Building Permit Application

Permit No.: **B19000497**

Building Address: 5042 Gaithers Chance Dr
 City: Dayton State: MD Zip Code: 21036
 Suite/Apt. #: _____ SDP/WP/BA #: GP-19-061
 Census Tract: _____ Subdivision: Gaithers Chance
 Section: _____ Area: _____ Lot: 6
 Tax Map: _____ Parcel: _____ Grid: _____
 Zoning: _____ Map Coordinates: _____ Lot Size: _____

Description of Work: New 2 story "Clifton Park II" FLV A, with 2 car side garage, 2 car side attached garage, morning room sitting area, suite 1st floor, 5th bedroom option, covered porch, finished lower level (office, media, exercise, wet bar, bathroom + powder room)
 Occupant or Tenant: _____

MODEL	CLIFTON PARK II	SET NO.	10300
DRAWING TITLE	BASEMENT PLAN	VERSION BY	A-JH
OPTION DESCRIPTION	FULL BASEMENT	DATE:	1/10/13
SHEET NO.	A-8	OPTION	FBA
	46.1

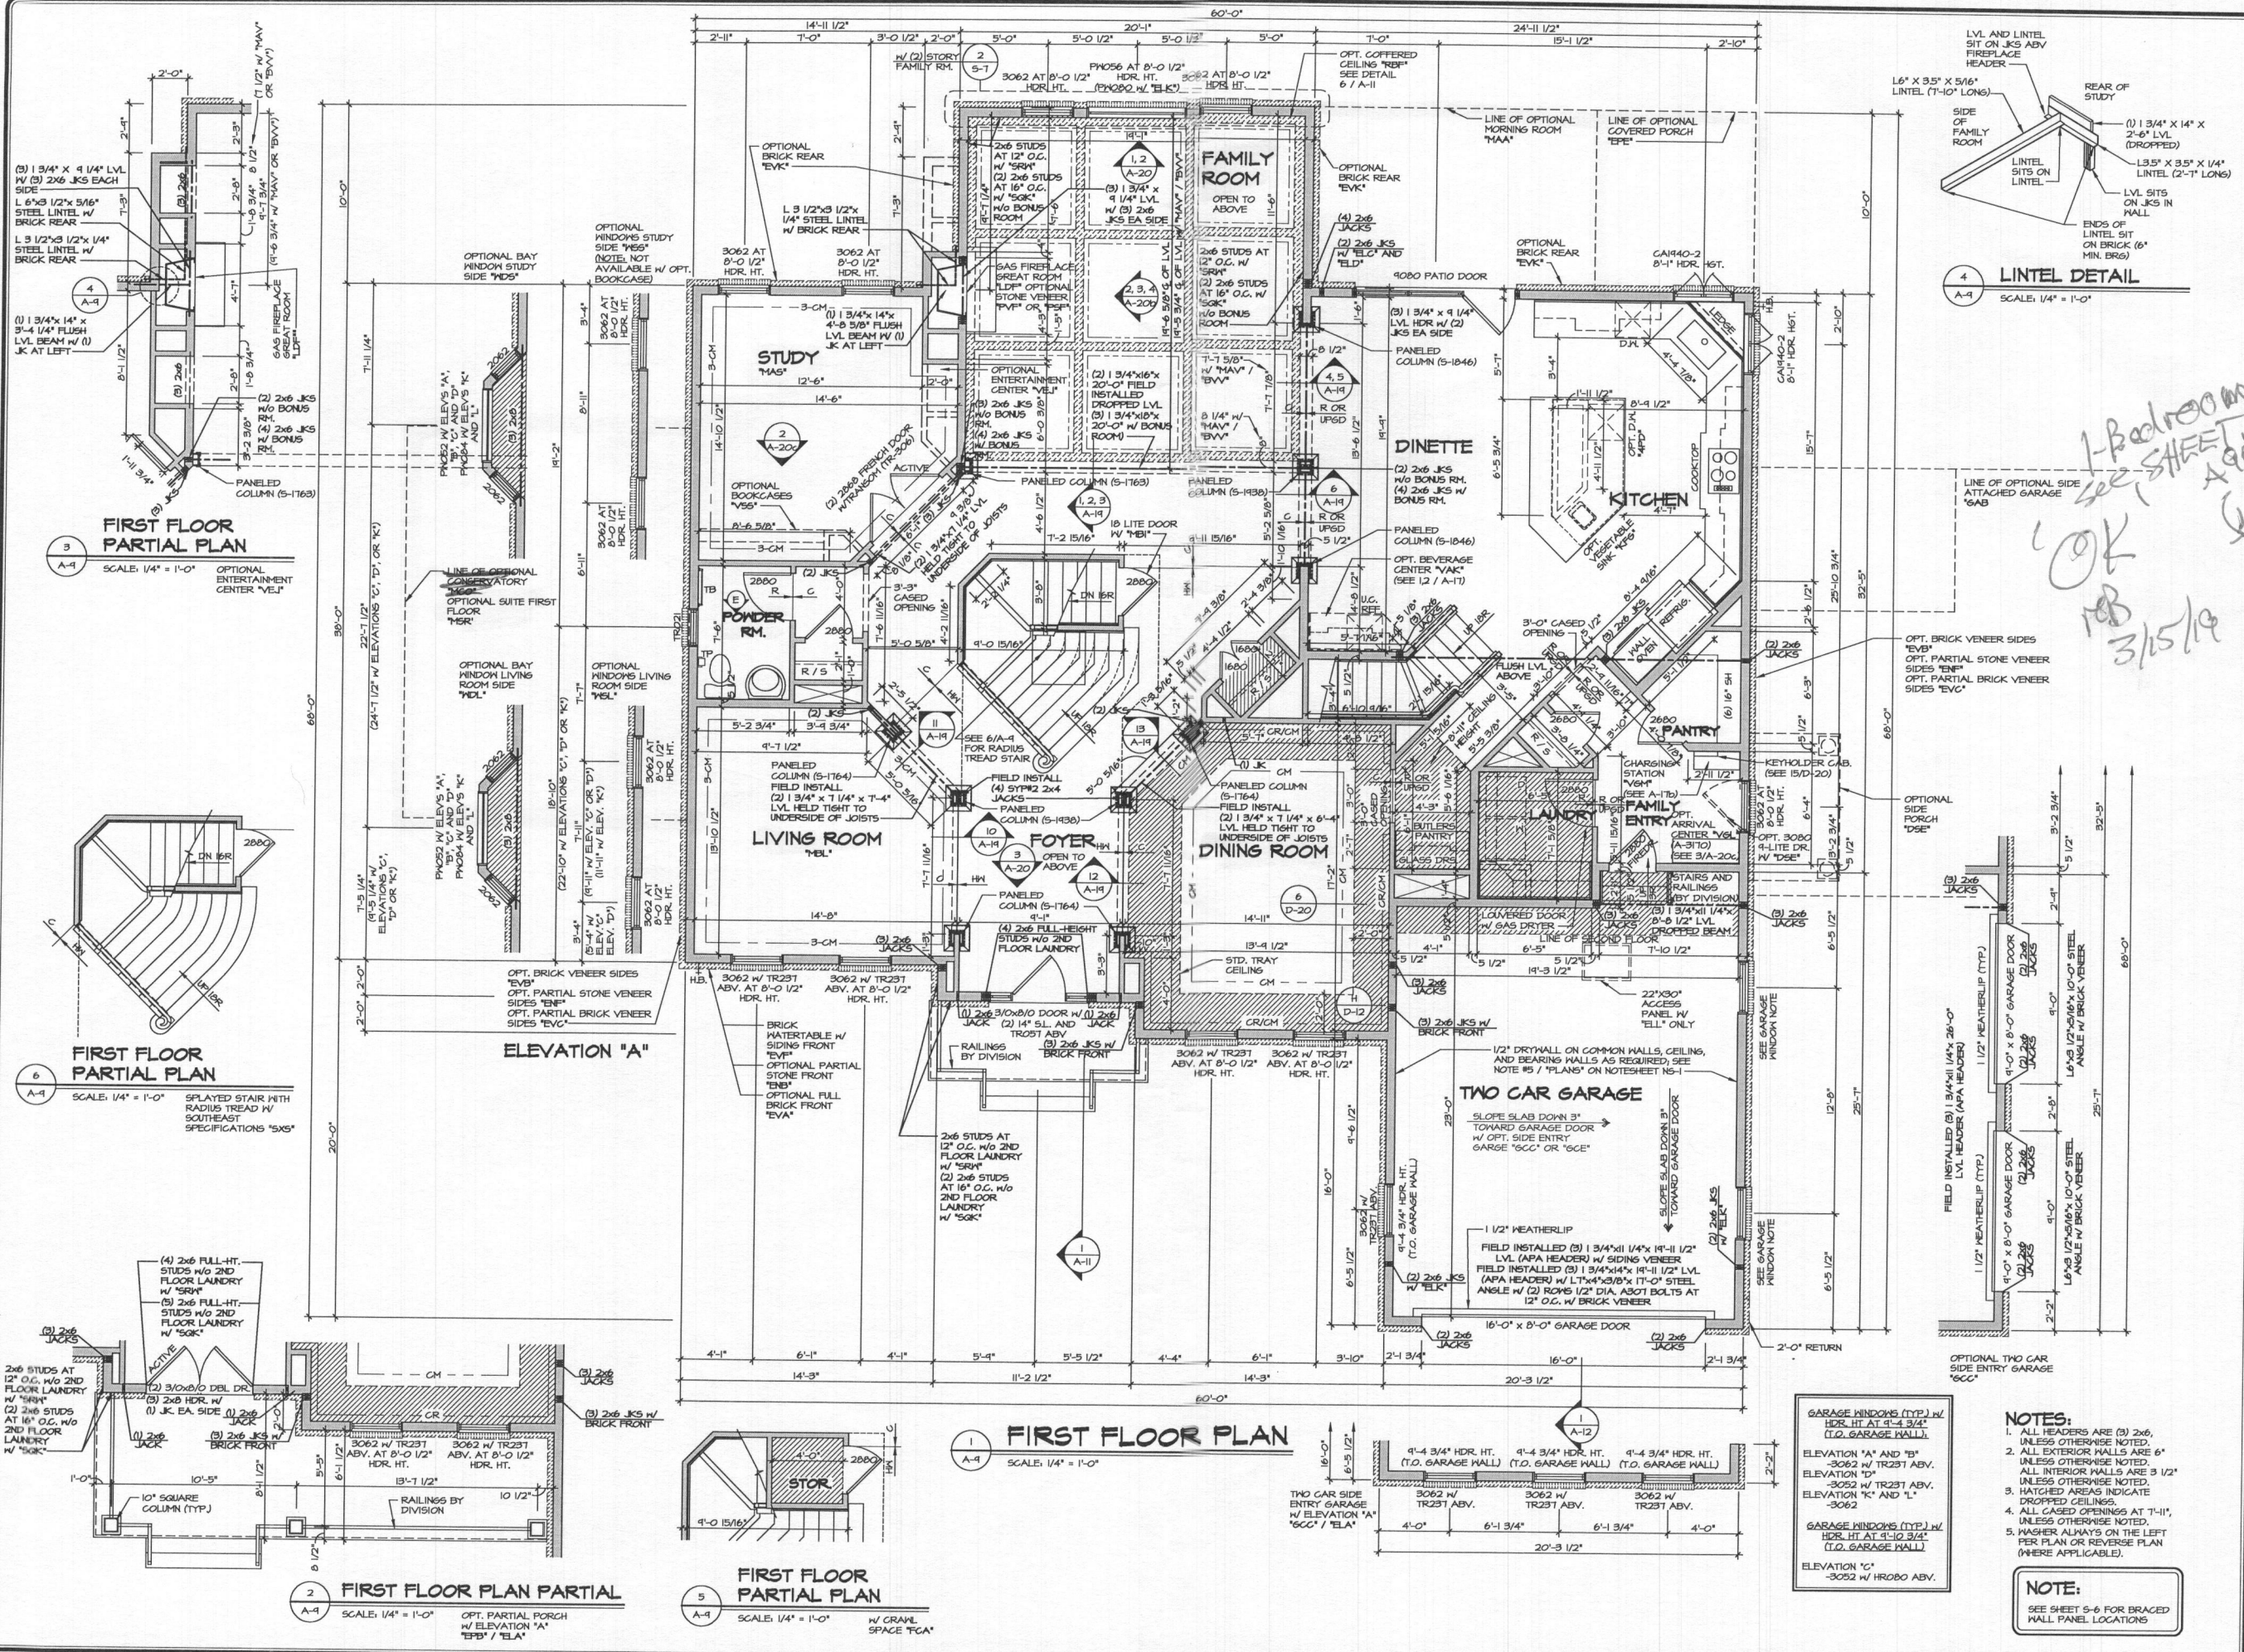
6 bedrooms this level

OK! reB 3/15/2019

Total: 6 Bedrooms

SHEET NO. 51
MODEL CLIFTON PARK II
DRAWING TITLE FIRST FLOOR PARTIAL PLANS
OPTION DESCRIPTION CONSERVATORY SUITE FIRST FLOOR

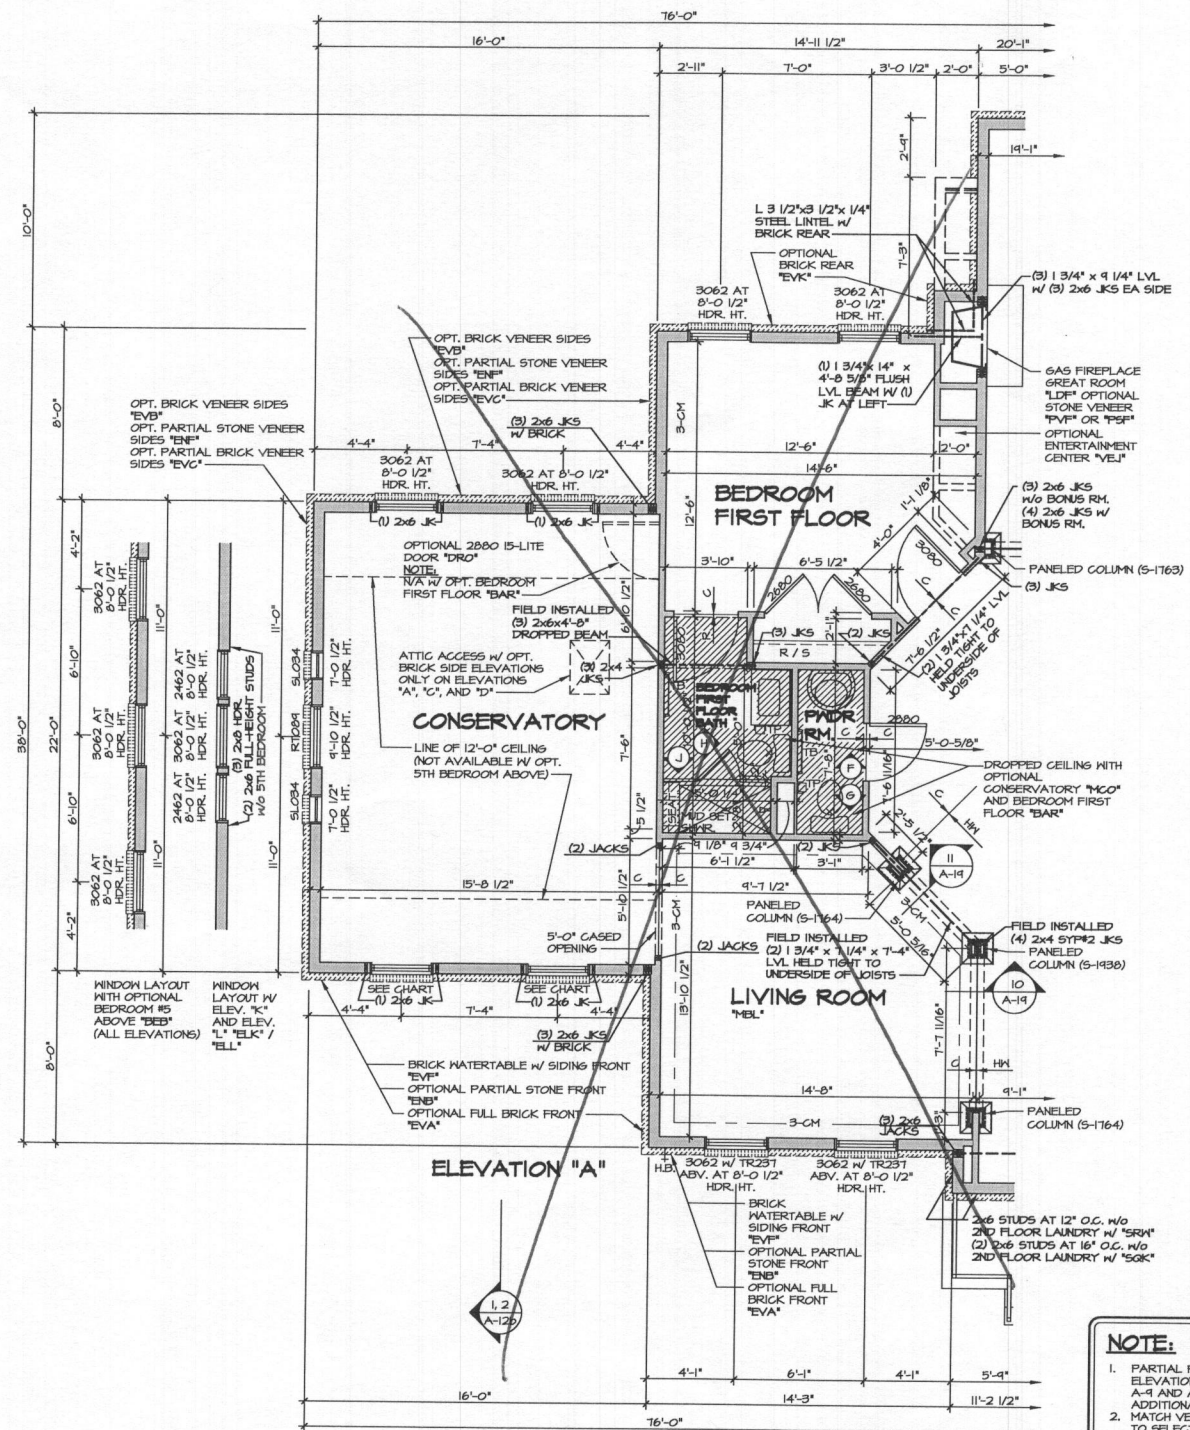
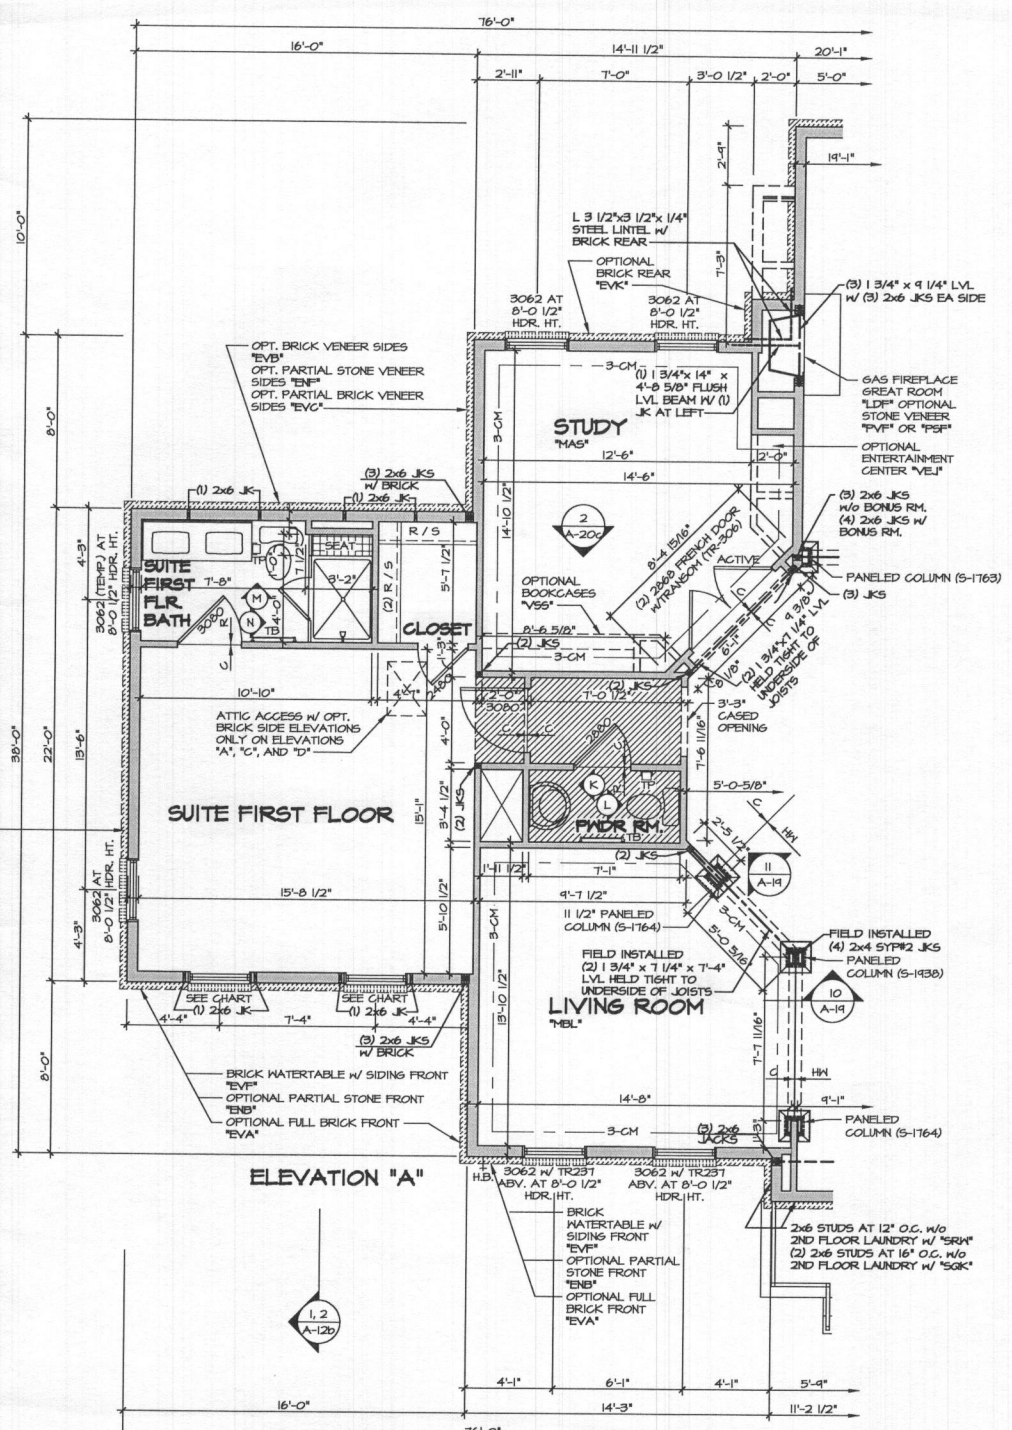
OK
RFB
3/15/19

SET NO. 10300
 MODEL CLIFTON PARK II
 DRAWING TITLE FIRST FLOOR PARTIAL PLANS
 DATE: 1/4/15
 OPTION MAA
 SHEET NO. A-9e
 OPTION DESCRIPTION MORNING ROOM
 52
 10300_01.PLT_MAA.dwg 10/23/18 - 8:41 AM

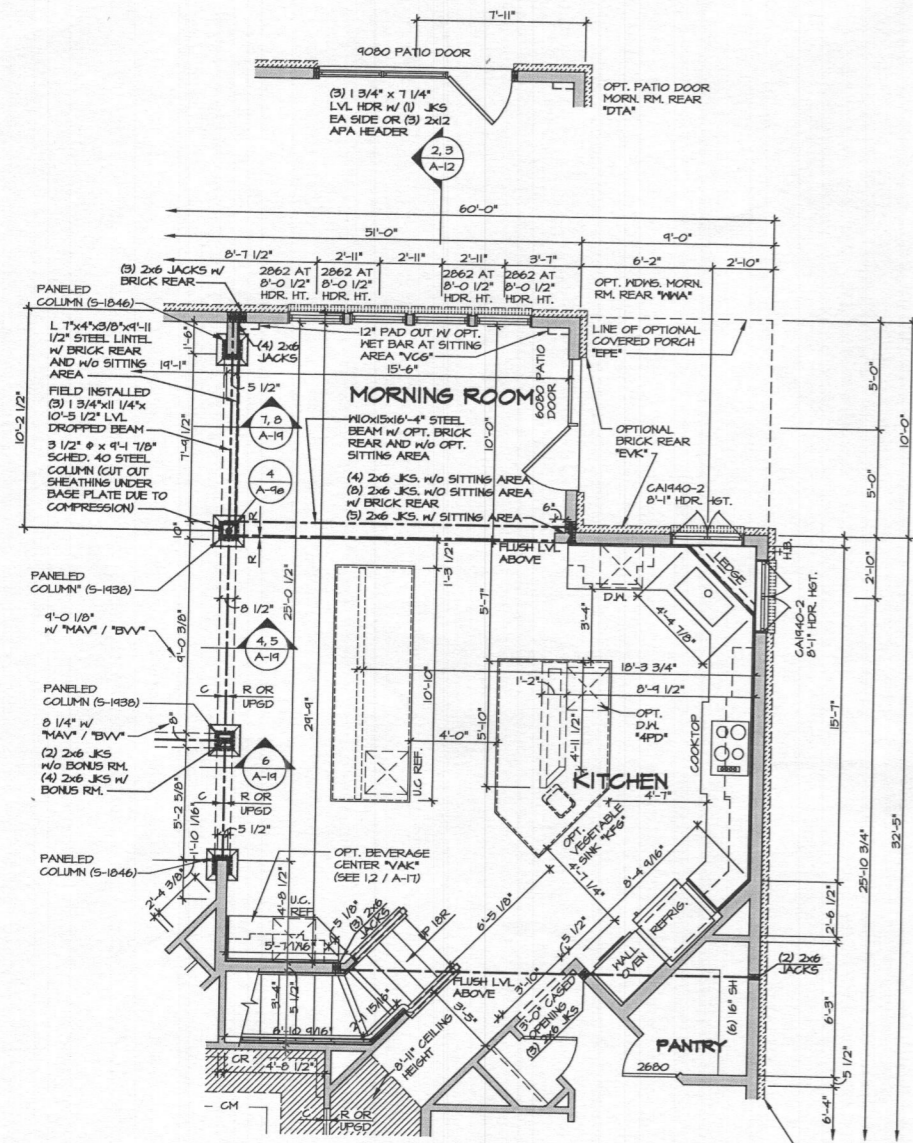
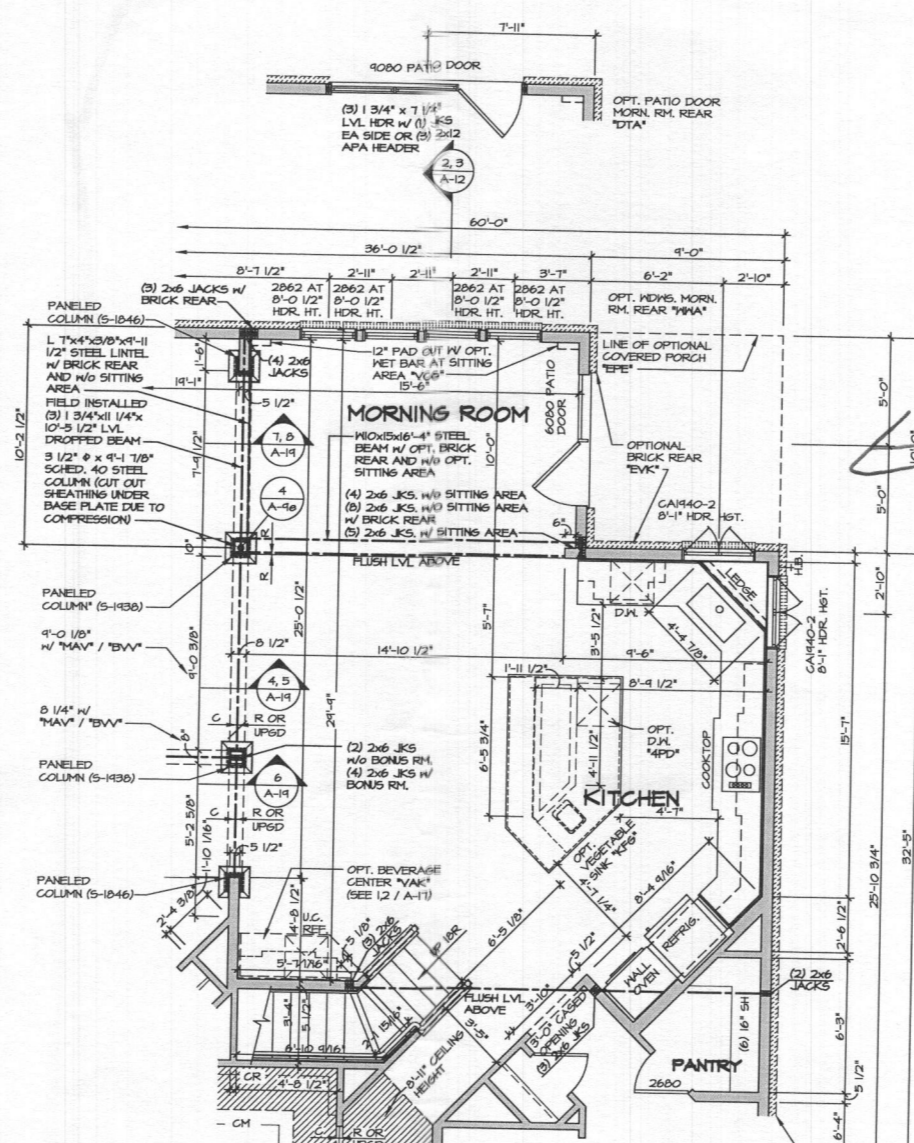
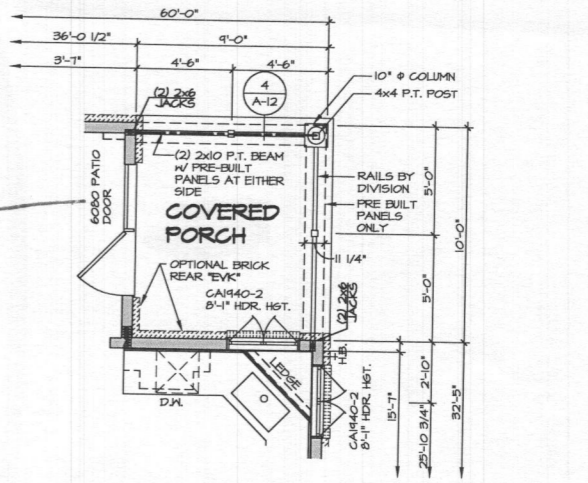
OK
red 3/15/19
